ZONING AMENDMENT,
PLANNED UNIT DEVELOPMENT &
SUBDIVISION STAFF REPORT

Date: November 2, 2006

<u>NAME</u>	Blue Marlin Construction, LLC
<u>SUBDIVISION NAME</u>	Brandonwood Subdivision
<u>LOCATION</u>	2910 and 2916 Cottage Hill Road (North side of Cottage Hill Road, 60'± West of Coventry Way)
<u>CITY COUNCIL DISTRICT</u>	District 5
<u>PRESENT ZONING</u>	R-1, Single-Family Residential
<u>PROPOSED ZONING</u>	R-3, Multi-Family Residential
<u>AREA OF PROPERTY</u>	1.1± Acres
<u>CONTEMPLATED USE</u>	Rezoning from R-1, Single-Family Residential district, to R-3, Multi-Family Residential district, to allow residential condominiums, and Planned Unit Development Approval to allow multiple buildings on a single building site. It should be noted, however, that any use permitted in the proposed district would be allowed at this location if the zoning is changed. Furthermore, the Planning Commission may consider zoning classifications other than that sought by the applicant for this property.
<u>TIME SCHEDULE FOR DEVELOPMENT</u>	Immediately

SITE PLAN

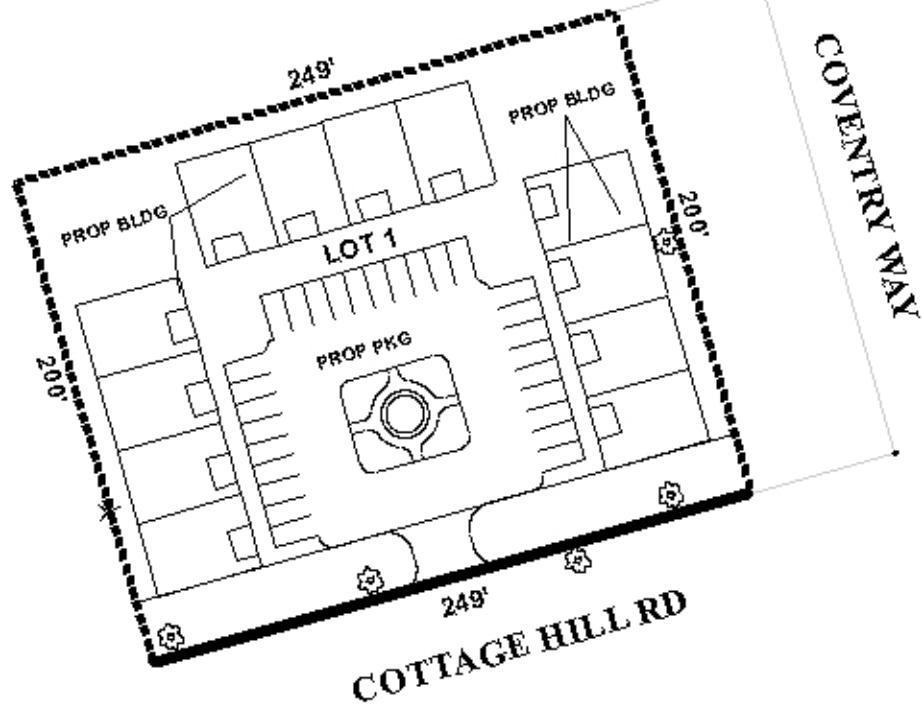
The site in question is two existing R-1, Single-Family Residential lots. The applicant proposes to remove the existing residences and redevelop the site to accommodate 12 single-family dwelling units as condominiums. The site plan depicts three “buildings” that will be separated from each other by a minimum of 10-feet, and all “buildings” will be a minimum of 25 feet from the front property line, 10-feet from the side property lines, and 10-feet from rear property line.

Conceptually, the development depicted on the proposed site/layout plan does not minimize impacts to the surrounding residential development, especially with the proposed 10-foot building setback along the sides and rear boundary of the site. It should be noted, however, that there is no indication on the site plan regarding the perimeter treatment of the property; specifically if a fence and/or landscape buffer will be provided to minimize impacts to adjacent lower-density residential developments. A privacy fence and landscape buffer is recommended for development on the West, East and North property lines. Furthermore, generalized landscaping proposed for the common areas should be depicted on the site plan, with the understanding that final landscape plan will be more detailed and require approval by the Urban Forester.

A detention basin may be required for the site. A note should be placed on the site plan, if approved, stating that maintenance of the detention basin common area, and any other common areas, are the responsibility of the development’s property owners.

Finally, the minimum building setback line required in Section V.D.9. of the Subdivision Regulations is not shown for the overall lot, but would be required on the Final Plat.

Rezoning: Based on the preceding, it is recommended that all applications be held over to the December 7th meeting, to allow the applicant to revise the plan and illustrate the garbage collection, drainage, landscaping and tree requirements, and extensive buffering. Revised materials, additional lot fees, mailing fees, and labels must be received in Urban Development by November 6th.
